Regarding: 2016/6333/P

Address: 1a Well Road, NW3 1LJ

Further to recent correspondence between yourself and Mr Jankowski, please accept this letter as an official objection to the proposed application – 2016/6333/P – which seeks approval for a boundary wall at rear terrace level between 1a Well Road and 2A Well Road, NW3.

Fig 1

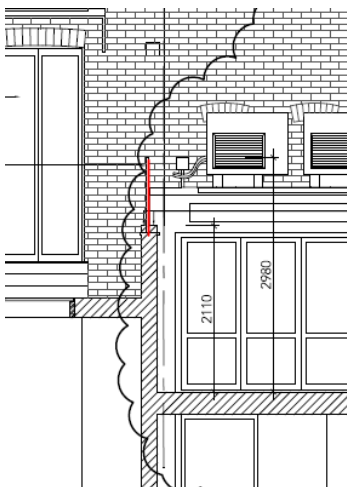
1. The boundary / raised wall in its current form (and, therefore, the existing proposal) has not only been built with disregard for the approved plans (2013/7179/P) but the existing plans are inaccurate and, as a result, the current proposal is misleading and misrepresentative of the completed wall.
 - **Fig 1** shows the proposed plans, as submitted, with the suggested position of glasswork highlighted in red. This forms the basis of the planning application. **Fig 2.** shows the actual position of the glasswork.

It is clear there is a significant discrepancy between the proposal and the reality and the drawings are, to this regard, misleading. The extra 150mm between the proposed position (submitted in the new drawings for application 2016/6333/P) and actual position is significant. Planning permission cannot be granted on the basis of inaccurate, misleading drawings

Fig 4

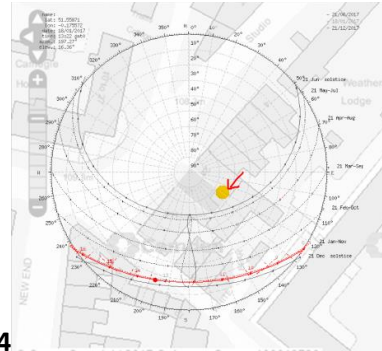
- The increased height, which now increases the height of the wall up to the roofline of properties to the rear, coupled with the tight spaces involved, is significant and damaging. **Fig 4** demonstrates the wall with the glass barrier as it currently stands. The tape on the wall demonstrates where it should have been built, as approved in planning 2013/7179/P—prior to which there was a glass screen extending to the current height of the brickwork. The height of the sun at 1605hrs, 17/01/17, has been shown as a yellow highlight. Although behind a building at this time, it must be noted that the angle of movement of the sun is shallow and the extra height of the glass significantly affects direct light to the terrace at 2A Well Road
Fig 5 shows the movement of the sun across the sky and the line of sight when viewed from 2A Well Road. The sun to the terrace at 2a is only available from the side obscured by the raised wall and raised glass at 1a.
